SUBJECT: MAYHEW AGGREGATES AND MINE RECLAMATION WATER DIVERSION IN TEMESCAL CANYON

Subject: Surface Mining Permit No 139 Revision No. 1
SCH#: 2013091018

DRAFT MITIGATED NEGATIVE DECLARATION, SURFACE MINING PERMIT (SMP) REVISION 139R1, PROPOSED REVISED PERMIT FOR MAYHEW AGGREGATES & MINE RECLAMATION, 24890 MAITRI ROAD, TEMESCAL CANYON AREA OF CORONA, RIVERSIDE COUNTY, SCH# 2013091018

**MAYHEW AGGREGATES AND MINE RECLAMATION
REVISED RECLAMATION PLAN AND MITIGATED NEGATIVE DECLARATION
CALIFORNIA ID # 91-33-0039, SMP #00139R1**

EXHIBIT "B1"

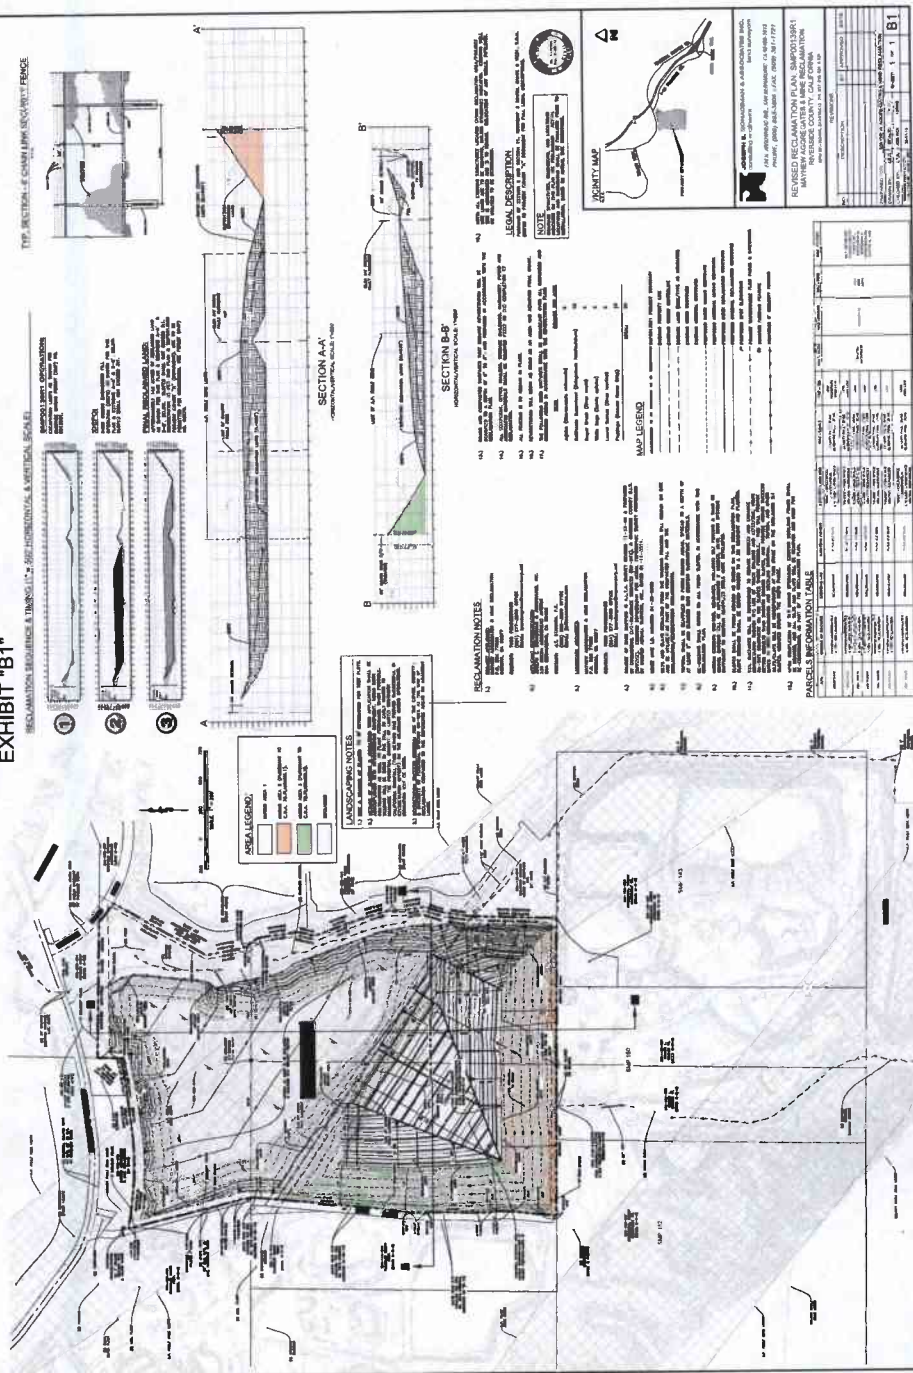
4. The proposed index contours on "Exhibit B1" should be redrawn to clearly show how the existing downdrain structure will be configured during this interim phase.

6. Additionally, in the event that the adjacent mines do not amend their reclamation plans, the scenario shown on "Exhibit B1" would become the final configuration of the mine. Therefore, the proposed 1.3H:1V cut slopes should be evaluated to determine what effect water filling the proposed retention area will have on slope stability.
